Access Compliance Report

Public Rights-of-Way

(Curb Ramps)

Intersection ID: 50248	Main Street: HANBERRY_BV	Cross Street: DERRYRUSH_DR	Location: NE
ADA ID: FA53A557773E	Ramp Type: PerpDiag	Initial Pass/Fail: Fail	Overall Compliance: No
Severity Score: 22.5			
Codes/Mitigation Info/Possible Solution		Field Measurements/Component Compliance

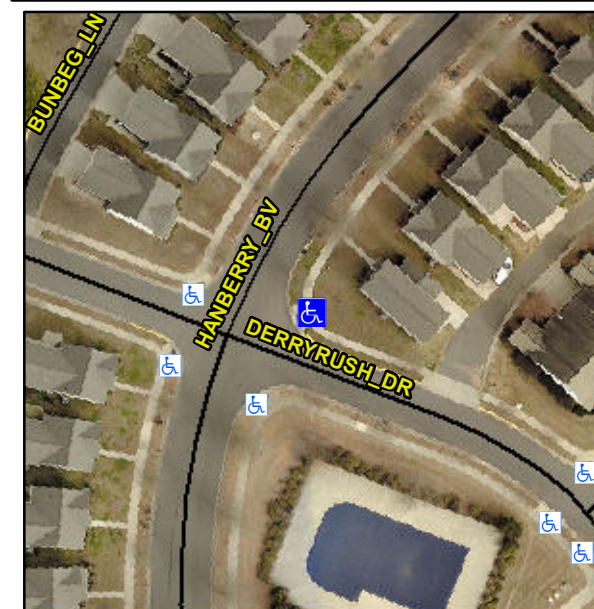
Not Found, R304.5.1, R304.2.2, R304.5.3

Compliance	Description	Data	Compliance	Description	Data
N/A	Ramp Length (in)	59.0	No	Ramp Slope (%)	10.2
No	Ramp Width (in)	39.0	No	Ramp XSlope (%)	2.6
N/A	Flare Type LT	N/A	N/A	Flare Type RT	N/A
N/A	Flare Slope LT (%)	N/A	N/A	Flare Slope RT (%)	N/A
N/A	Flare Traversable LT?	N/A	N/A	Flare Traversable RT?	N/A
N/A	Landing Length (in)	N/A	N/A	DWS Provided?	N/A
N/A	Landing Width (in)	N/A	N/A	DWS Contrast?	N/A
N/A	Landing Slope (%)	N/A	N/A	DWS Length (in)	N/A
N/A	Landing X Slope (%)	N/A	N/A	DWS Full Width?	N/A
N/A	Landing Curb? (Y/N)	N/A	N/A	DWS Offset (in)	N/A
N/A	Shared Landing?	N/A			
N/A	Gutter Ponding?	N/A	N/A	Gutter Slope (%)	N/A
N/A	Gutter Lip Ht (in)	N/A	N/A	Gutter X Slope (%)	N/A
N/A	Painted X Walk1?	No	N/A	Painted X Walk2?	No
	X Walk 1 Direction	To NW		X Walk 2 Direction	To SW
N/A	X Walk 1 Width (in)	N/A	N/A	X Walk 2 Width (in)	N/A
	X Walk 1 Slope (%)	3.6		X Walk 2 Slope (%)	0.6
	X Walk 1 X Slope (%)	1.9		X Walk 2 X Slope (%)	4.1

Remove & Replace Curb Ramp With Two New Directional Ramps or Equivalent.
